Will the repair of the Cairngorm Funicular Railway work (2)?

Figure 2-10 Loosened rock bolt in anchor block (refer defect 7)

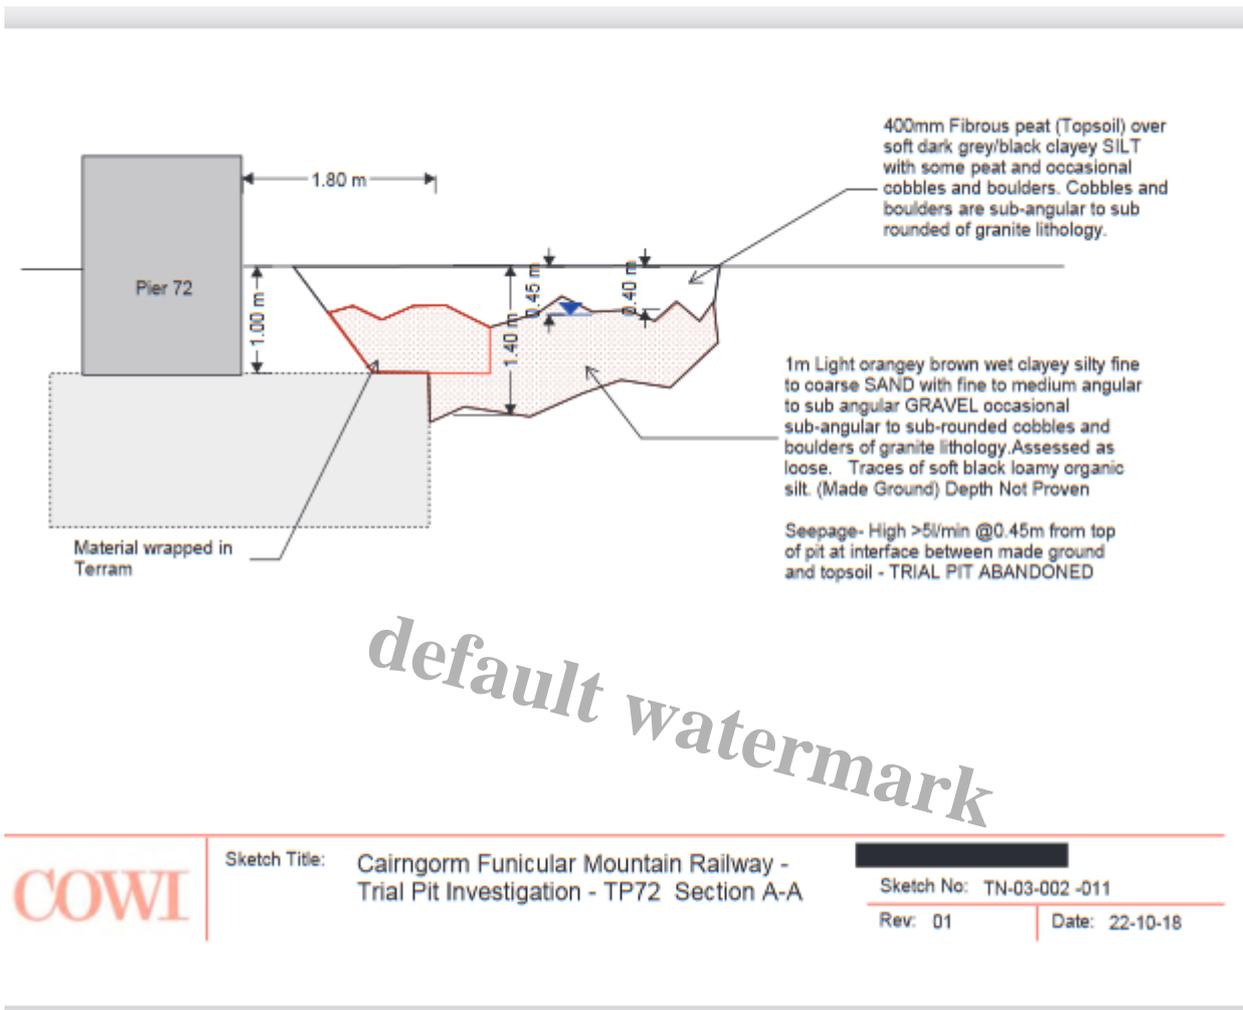
Question (1) Where was the routine maintenance schedule that should have been carried out by maintenance staff that allowed this to happen?

Question (2) Is it possible to tighten this bolt taking into account the corrosion on the threads?

It is not known which of the Anchor Blocks this is, or how many of its securing bolts were loose, but these bolts are there for a reason. These Anchor Blocks take the weight/ strain of the approx. 2 x 300m of uphill concrete beams, which are continually trying to slide downhill under the force of gravity. They should be checked on a regular basis and the nuts torqued to a specific setting. Depending on how many of the bolts on any one Anchor Block were loose, the one below it could have been carrying the full weight of 600m of track! You can see from the corrosion on the rock bolt that the nut has been loose for some time.

Question (3) Why was this not noticed at previous inspections?
